Planning and Development (Technical Amendment—Miscellaneous Amendment) Plan Variation 2015 (No 1)*

Technical Amendment No 2015—01

Technical Amendment to the Territory Plan Variation 2015-01

Miscellaneous amendments and removal of redundant provisions

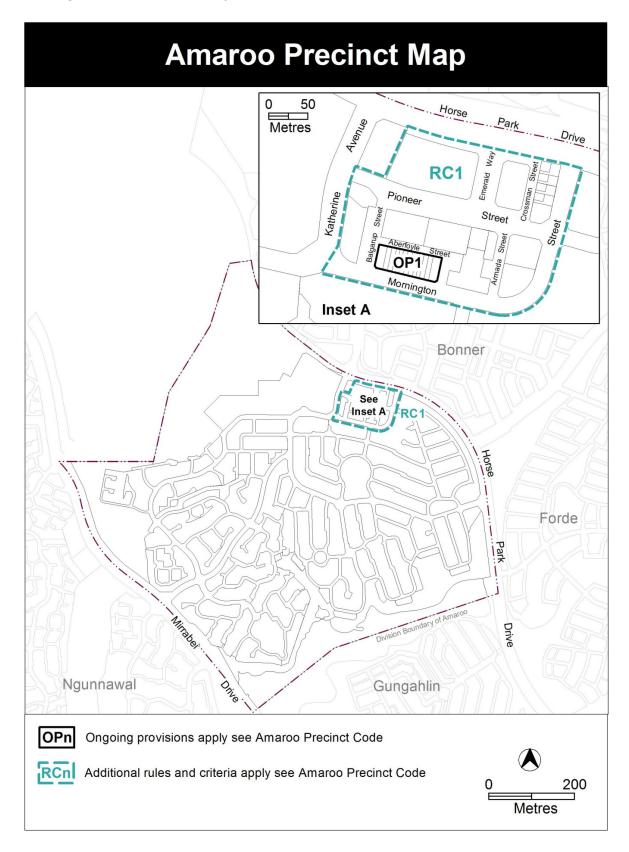
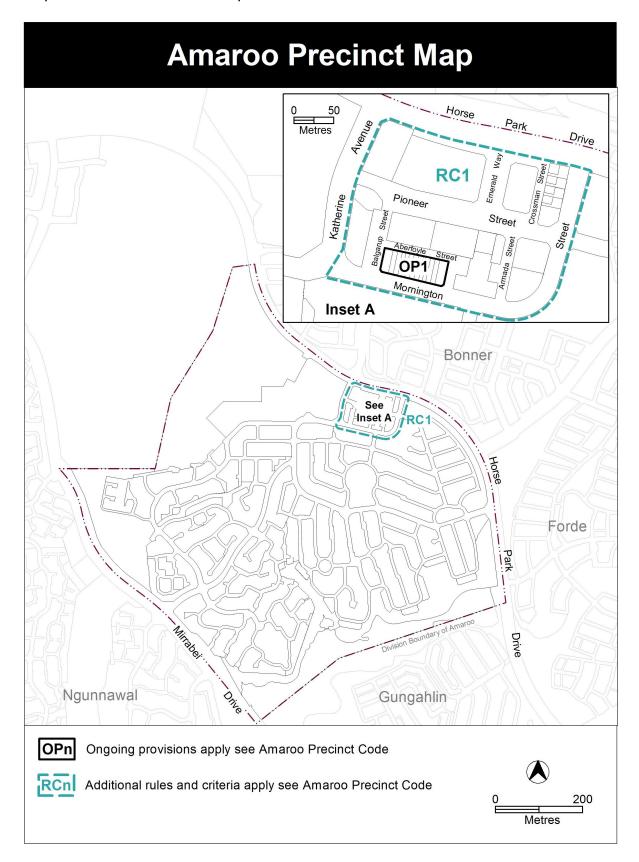
Amend wording in criterion C35 to refer to the correct Crime Prevention Through Environmental Design General Code.

5.3 Lighting		
Rules	Criteria	
R35	C35	
External lighting is provided to building frontages, to all pathways, roads/laneways and car parking areas in accordance with Australian Standard 1158.1.3 <i>Pedestrian Lighting</i> .	External lighting is provided in accordance with the <u>Crime Prevention Through Environmental Design General Code</u> .

Figure 4 Building and site controls – RC5 Commercial local centre area

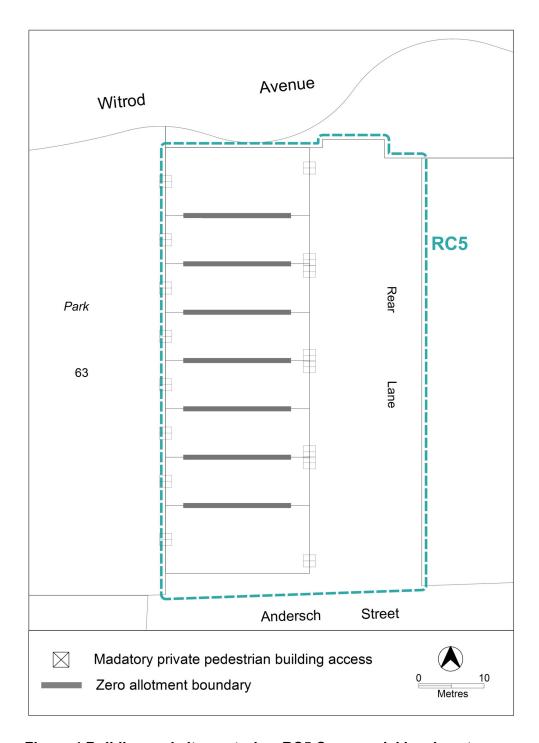
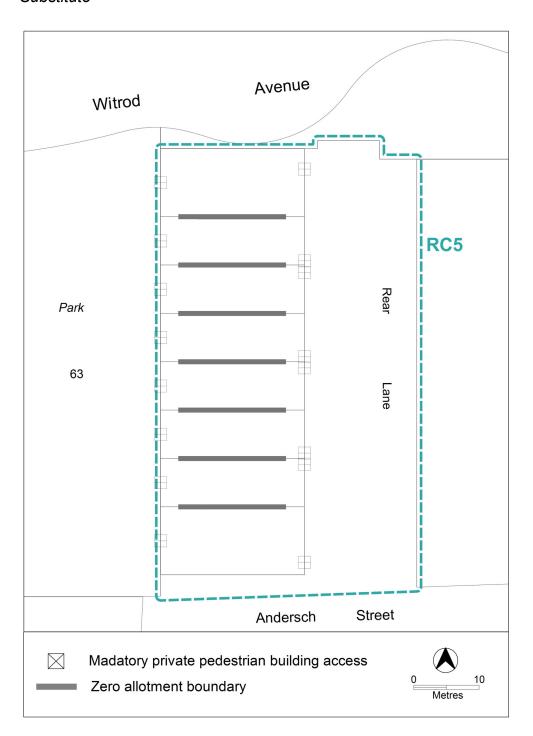
Replace Figure 4 to rectify the incorrect reference to RC4. The amended diagram shows the correct reference to RC5.

Figure 8 Casey residential area 4

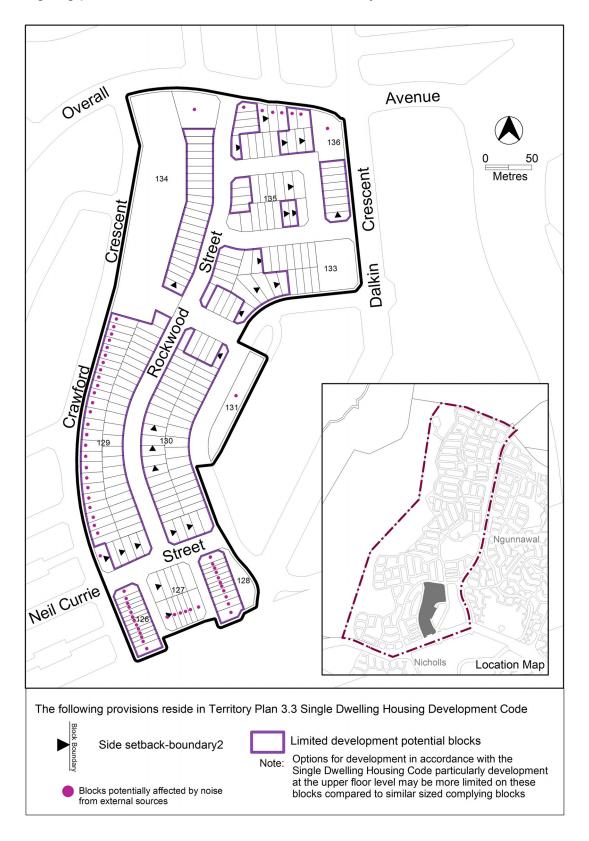
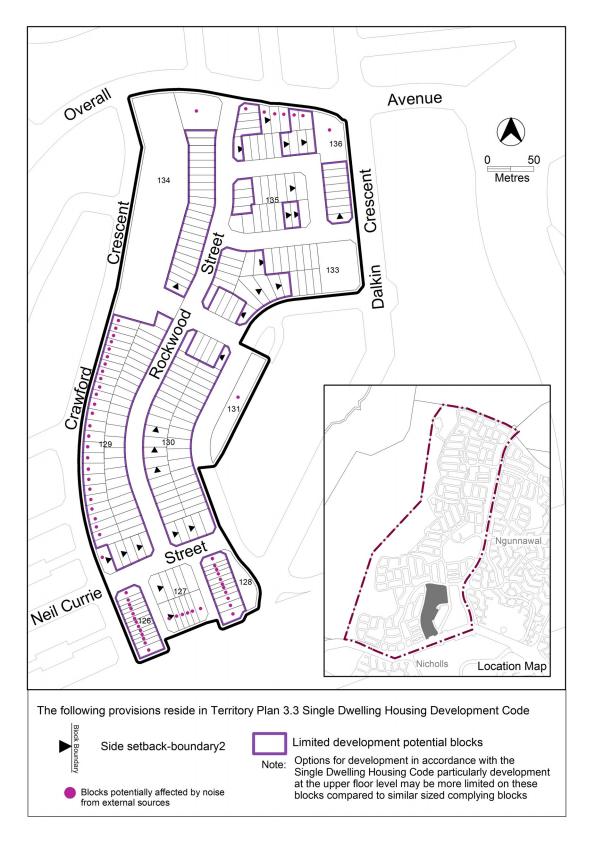
Replace Figure 8 with an amended diagram to show allow previous approved ongoing provisions for OP4 that were inadvertently omitted.

Figure 3

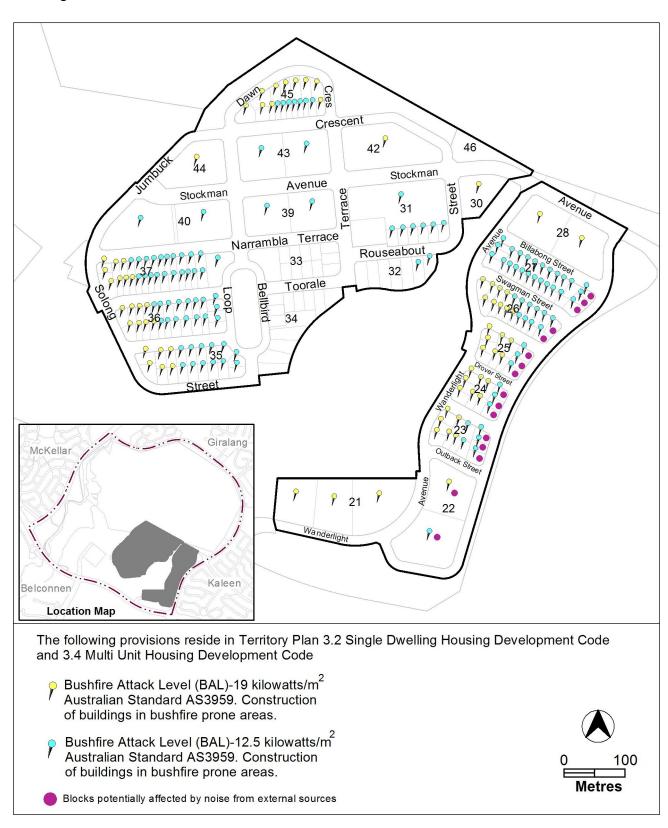
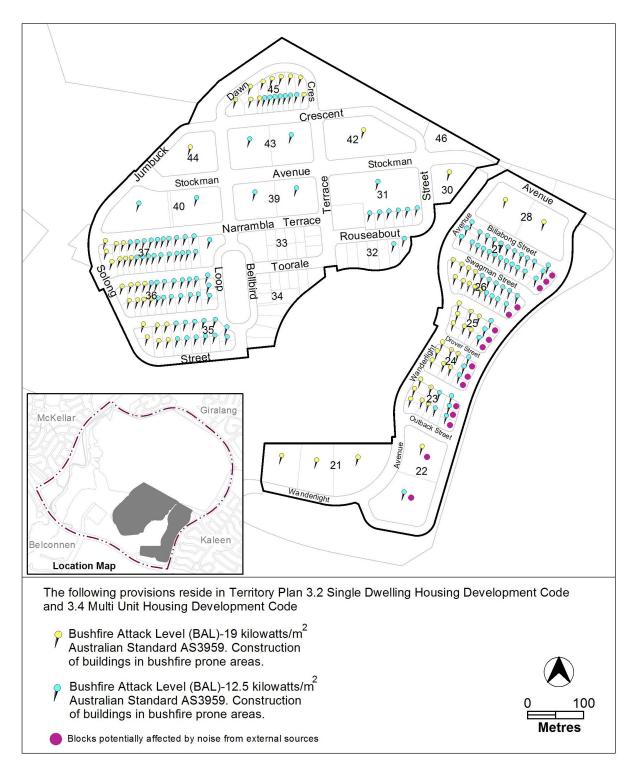
Rectification to omission of BALs from ongoing provisions OP1 Lawson residential area Figure 3

3. Amaroo Precinct Map

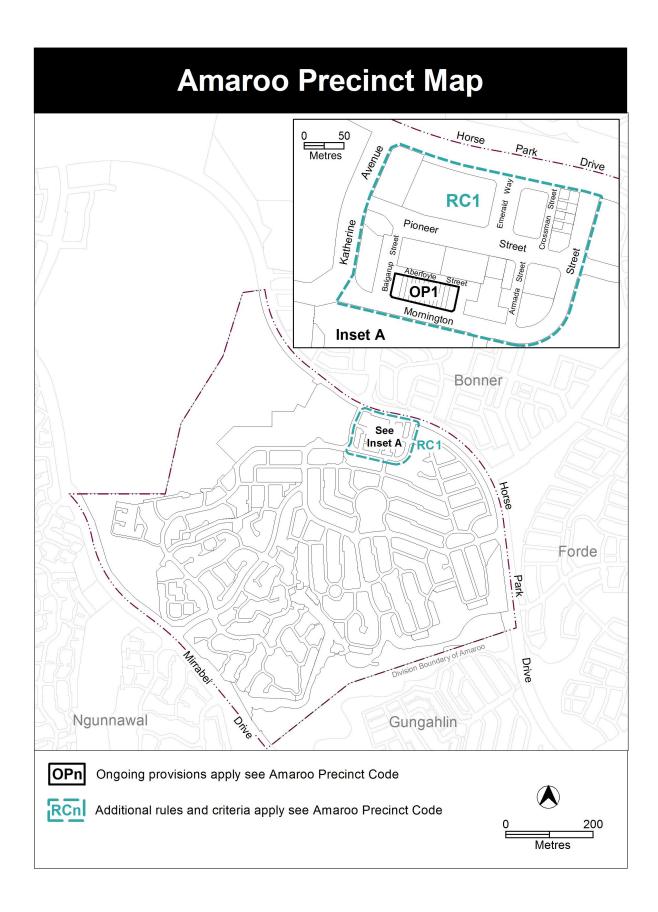
The remainder of the Amaroo group centre was uplifted after the new Territory Plan came into effect and the Amaroo Precinct Map and Code was introduced in October 2013. However, the existing service station site (Commercial CZ3 services zone in the new Territory Plan) was inadvertently omitted from inclusion into RC1 Amaroo Group Centre area on the Amaroo Precinct Map. This technical amendment seeks to rectify this omission.
